Parlier HS Stadium Replacement

PBK PROJECT NO.: 250093
DSA FILE NO.: 10-H12
DSA APPLICATION NO.: 02-124002 _ PARLIER HS STADIUM REPLACEMENT

NOTICE TO BIDDERS

2
SN3.3

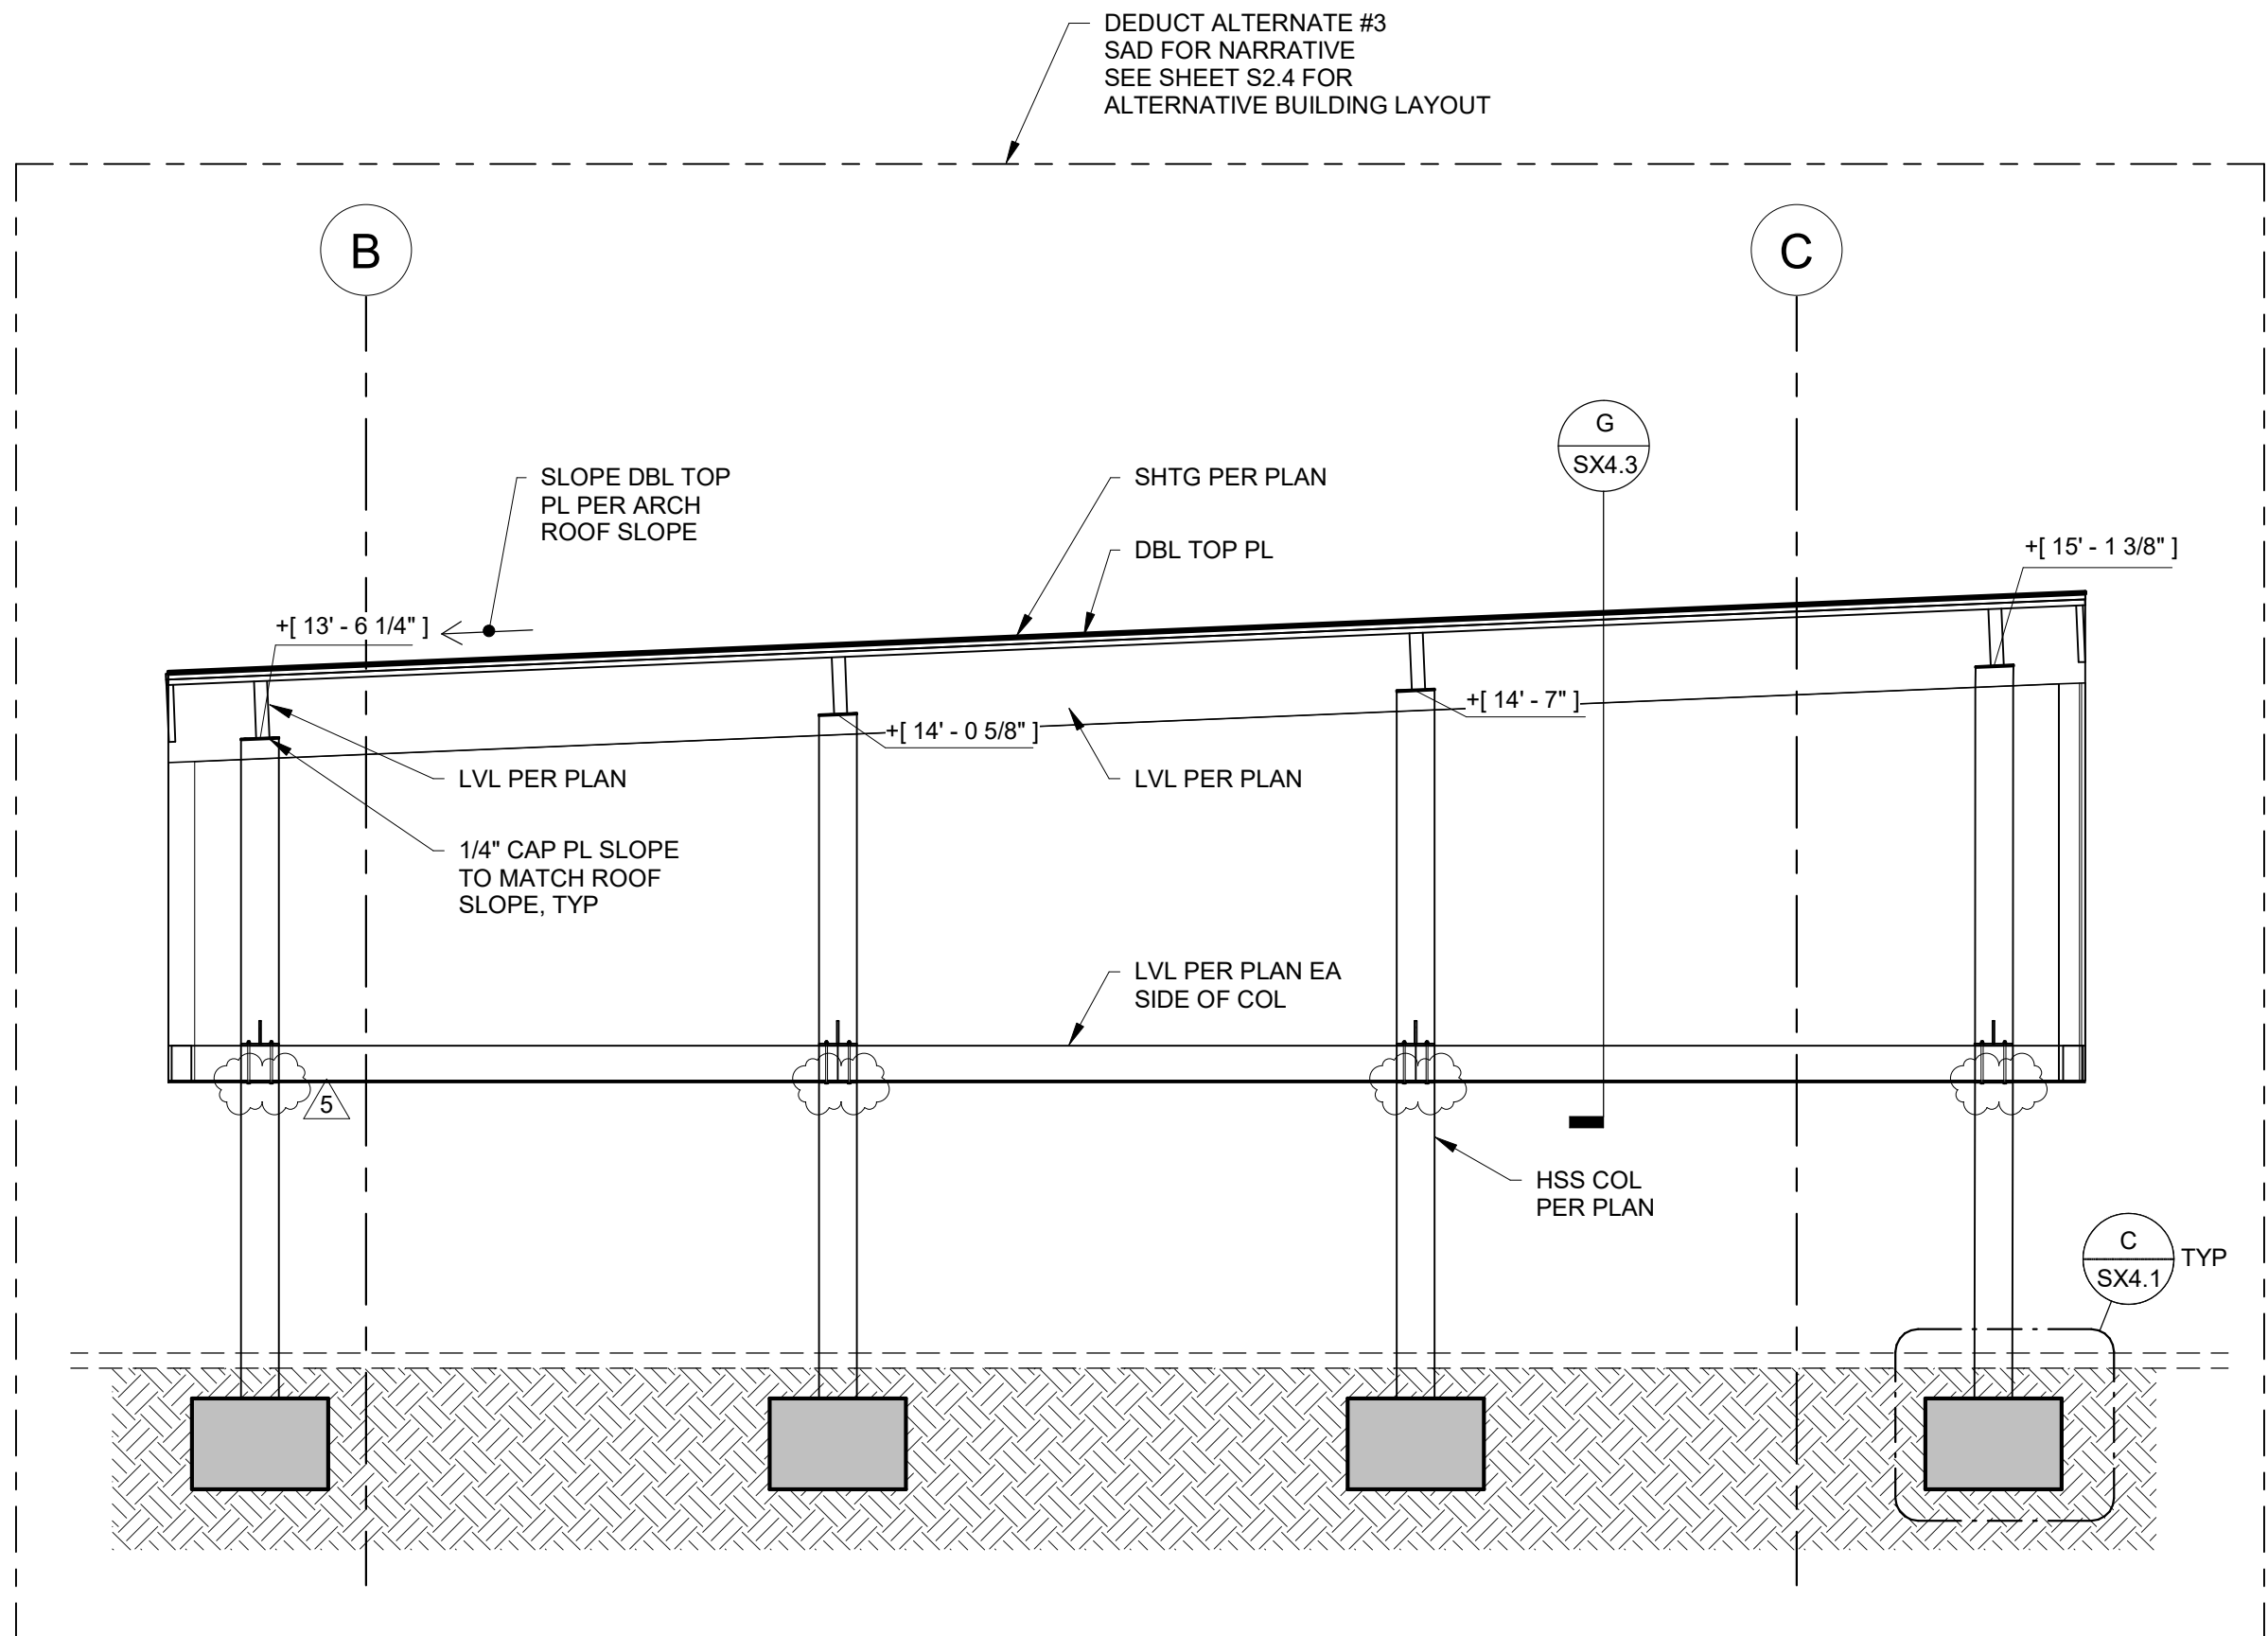
1. Refer to sheet SN3.3 "BUILDING ELEVATIONS No. 1- BUILDING N"
 - a. Remove and replace sheet SN3.3 "BUILDING ELEVATIONS No. 1- BUILDING N" with herein attached sheet SN3.3 "BUILDING ELEVATIONS No. 1- BUILDING N" identified with AD6 on the bottom right-hand corner.

Note: Changes to sheet shown on elevation 4/SN3.3
